Groundwater Application Review Summary Form

Application # G- <u>19339</u>
GW Reviewer <u>Gabriela Ferreira / Dennis Orlowski</u> Date Review Completed: <u>February 6, 2023</u>
Summary of GW Availability and Injury Review:
Groundwater for the proposed use is either over appropriated, will not likely be available in the amounts requested without injury to prior water rights, OR will not likely be available within the capacity of the groundwater resource per Section B of the attached review form.
Summary of Potential for Substantial Interference Review:
There is the potential for substantial interference per Section C of the attached review form.
Summary of Well Construction Assessment:
☐ The well does not appear to meet current well construction standards per Section D of the attached review form. Route through Well Construction and Compliance Section.
This is only a summary. Documentation is attached and should be read thoroughly to understand the

Application G-19339

Well Statistics

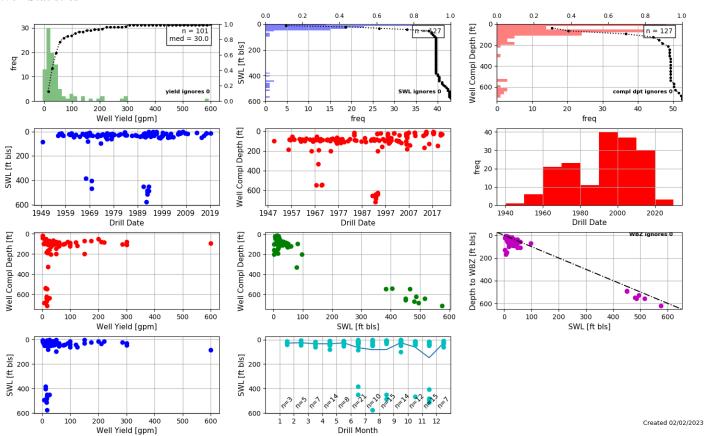
Basis for aquifer confinement evaluation: Water level elevations for nearby wells are generally near depth to the waterbearing zone as shown on the attached well statistics for alluvial wells in the vicinity of the proposed POA. Well logs for nearby wells (MULT 609, MULT 1684, MULT 1685, and MULT 1707) do not report extensive confining units; minor amounts of sandy or silty clay are present near surface but do not appear to significantly produce aquifer confinement.

Water-Level Measurements in Nearby Wells

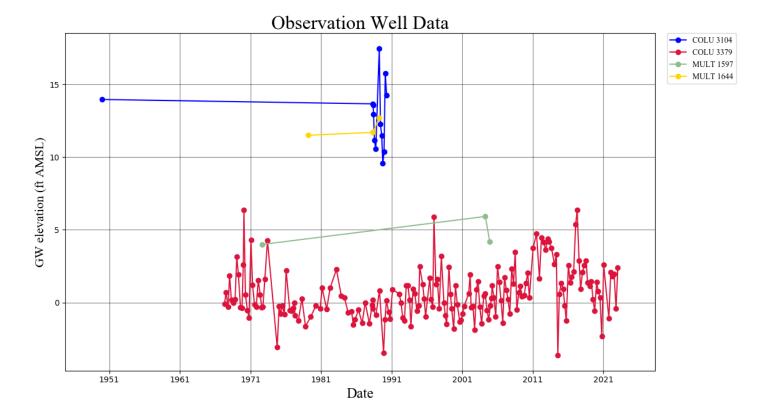
Water level data from the alluvial aquifer is provided in the attached hydrograph for COLU 3104 (8 miles north), COLU 3379 (9 miles north), MULT 1597 (5 miles southwest) and MULT 1644 (2.4 miles east). The water levels for all three wells are very stable with seasonal variation of ~5 to 7 feet. Similar stability is expected for groundwater levels closer to the proposed POA, based on the effective hydraulic connection with the Multnomah Channel and large storage capacity and permeability of the USA (primarily sand and gravel). In order to support future understanding and management of the groundwater resource in this area, the conditions listed in Item B1(d)(i) and Item B2(c) are recommended.
